# Access Compliance Report

## Public Rights-of-Way

### (Curb Ramps)

Intersection ID: 11362	Main Street: CALLISON_CT	Cross Street: TIMBERTOP_LN	Location: NW
ADA ID: 396EE272CCEF	Ramp Type: BlendTrans1	Initial Pass/Fail: Fail	Overall Compliance: No
		Severity Score: 10

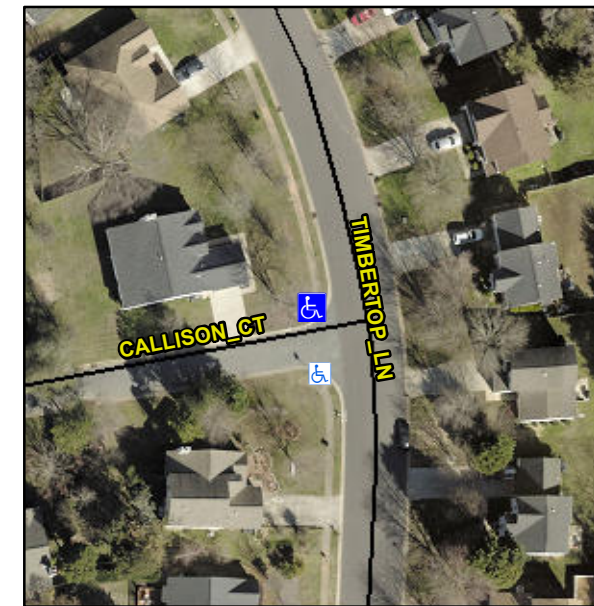
**CURB GAP 3.0**

**Not Found, R304.5.1, R304.5.3**

**Remove & Replace Curb Ramp With Two New Directional Ramps or Equivalent.**
